**Report Title:** Arboricultural Impact Assessment

**Project: Title:** Proposed Large Scale Residential Development at  
“Gowan Motors Compound” site, Merrion Road, Dublin 4.

**Applicant:** 1 Merrion Compound Land Limited

## 1. Response to LRD Opinion

Image 2. Example of Tree Trunk Protection with Willow screen wrapping (or similar approved).

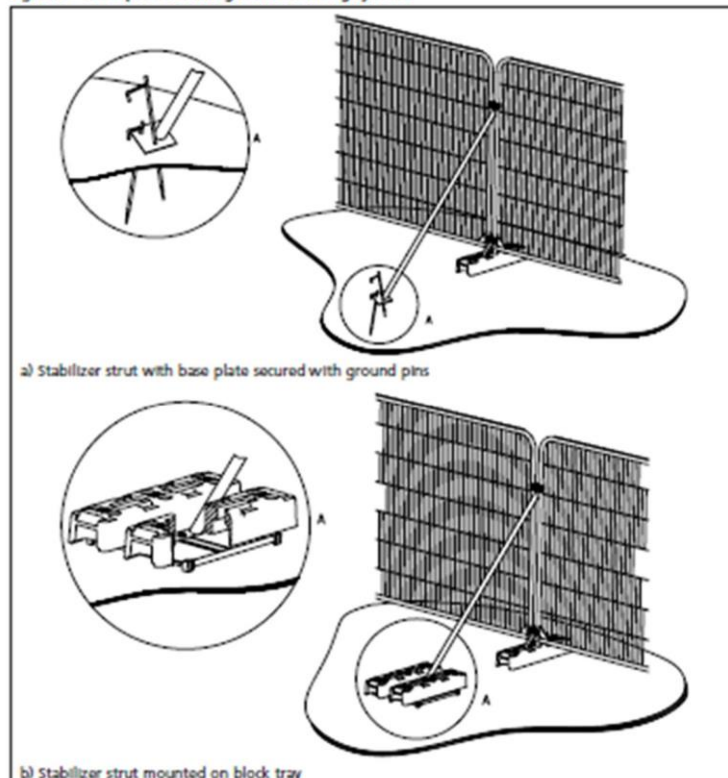
- The arboricultural survey shall be revised with a measured tree canopy. The location of the proposed building façade shall be assessed for impact on the tree canopy. Details of tree trunk protection measures shall be included.

- 1.4 The street tree shall be protected by protective fencing and/or trunk wrapping during the course of any site development works. Refer to Appendix 2 for examples of suitable Tree Protection Root Barriers. Refer also to the Tree Root Protection Plan drawing ref: TMS.LD.05.24.02A. Refer also to BS 5837:2012 paragraph 6.2 - Barriers and Ground Protection. Great care shall be exercised during the demolition and construction phase to protect the tree. Damage to tree roots or stem structures will be avoided
